# **Intel<sup>®</sup> Mobile Pentium<sup>®</sup> II Processor Specification Update**

Release Date: August 2000

Order Number: 243887-023

The Mobile Pentium<sup>®</sup> II processor may contain design defects or errors known as errata which may cause the product to deviate from published specifications. Current characterized errata are documented in this Specification Update.

Old Mobile Pentium® II Processor in Mini-Cartridge Package Label with Supplier Matrix Mark

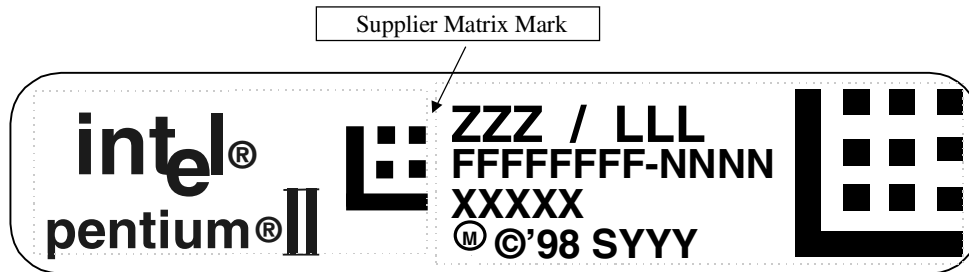
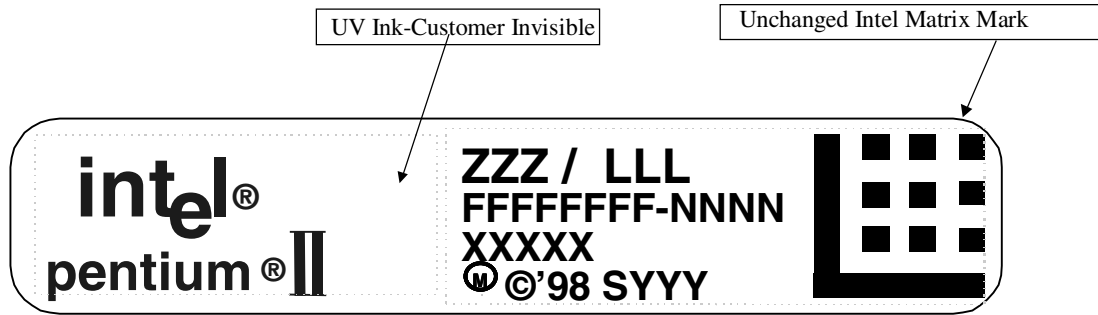
New Mobile Pentium® II Processor in Mini-Cartridge Package Label with Supplier Matrix Mark Removed

**Figure 5.6. Cross Sectional View with Vertical Dimensions**

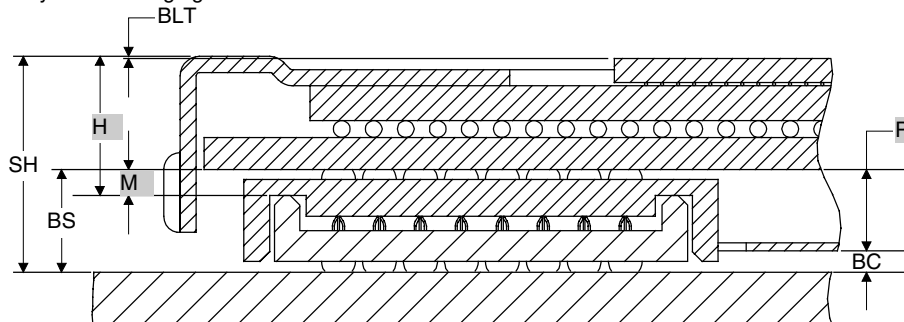
### B1. Misabeled Vertical Dimension Parameters

Figure 5.6 in the *Mobile Pentium® II Processor at 233 MHz, 266 MHz, and 300 MHz* datasheet should be replaced by the following figure:

**Figure 5.3. Surface-Mount BGA1 Package—Top and Side View**

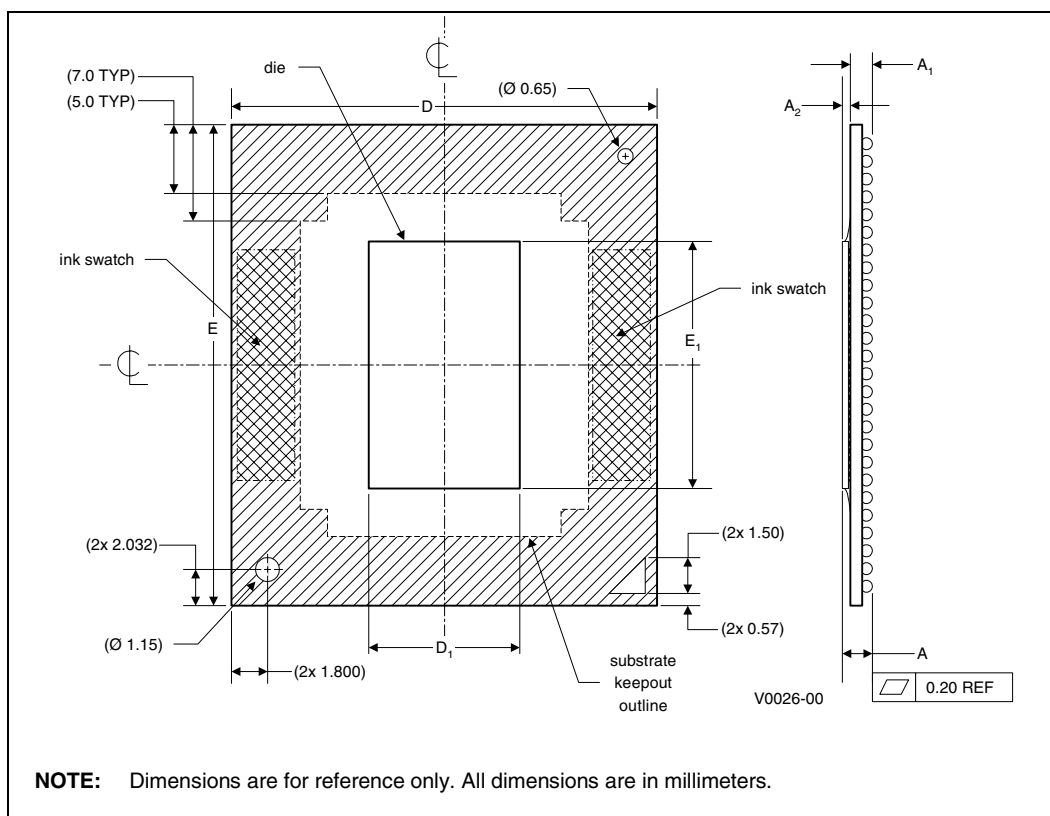
The following table and figures show the updated mechanical specifications for the BGA1 package, listed as Table 5.2, Figure 5.3 and Figure 5.4, respectively, in the *Mobile Pentium® II Processor in BGA Package at 366 MHz, 333 MHz, 300PE MHz, and 266PE MHz* datasheet.

Figure 3.3 Generic Clock Waveform

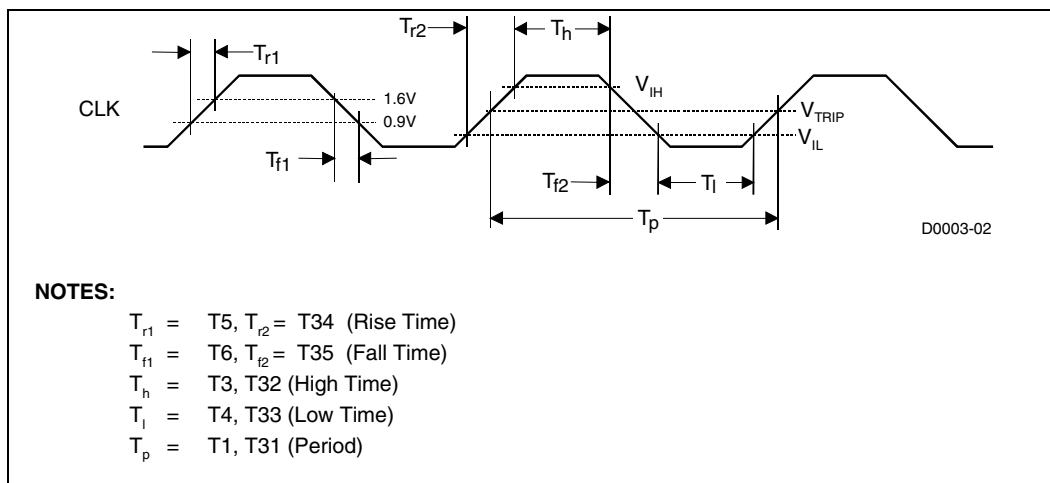
### B14. Generic Clock Waveform Figure

Figure 3.3 in *Mobile Pentium® II Processor in Mini-Cartridge Package at 366 MHz, 333 MHz, 300PE MHz, and 266PE MHz* datasheet (Order Number 245108), and the *Mobile Pentium® II Processor in BGA Package at 366 MHz, 333 MHz, 300PE MHz, and 266PE MHz* datasheet (Order Number 245106) has been updated. The following figure is to replace the ones in the above documents.

Figure 1. TAP Gageable Thread Clarification

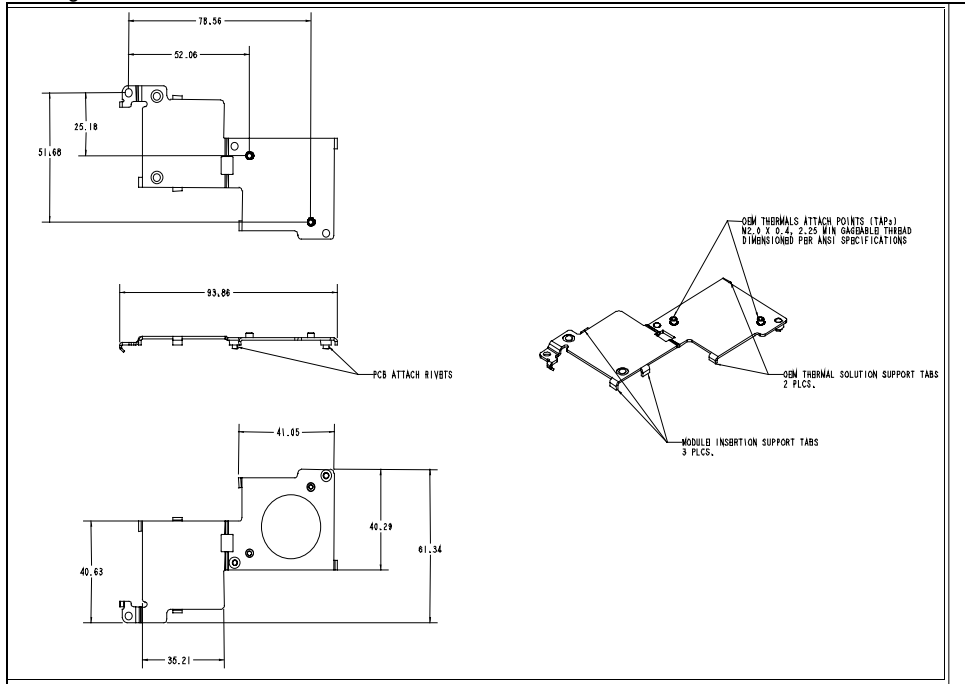
In the *Intel® Pentium® II Processor Mobile Module : Mobile Module Connector 1 (MMC-1)* and the *Intel® Pentium® II Processor Mobile Module : Mobile Module Connector 2 (MMC-2)* datasheets (Order Numbers 243667 and 243668, respectively), the thermal attach point (TAP) gageable thread specification was not clearly identified in Figure 14, of Section 5.2. The following is the TAP clarification:

OEM Thermal Attach Points (TAPs) M2.0 x 0.4, 2.25 min gageable thread dimensioned per ANSI specification.

See Figure 1 below for more information.
